February 24, 2020

Product Change Notice - Bed tilt aluminum frame

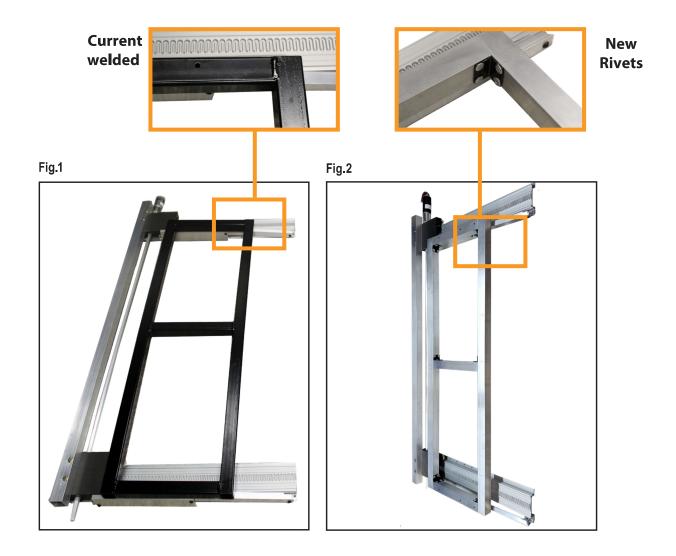
Please be advised, to reduce the overall weight of the system, LCI intends to change its bed tilt frames from welded steel (Fig. 1) to aluminum with rivets (Fig. 2).

- System with welded steel frame 39.40 lbs
- System with aluminum riveted frame 26.21 lbs
- Difference in weight between two systems 13.19 lbs

There is no change in fit, form, function or installation with the change in material. There is no price change and no part number change. The change is expected to take place in the first quarter when current inventory is depleted.
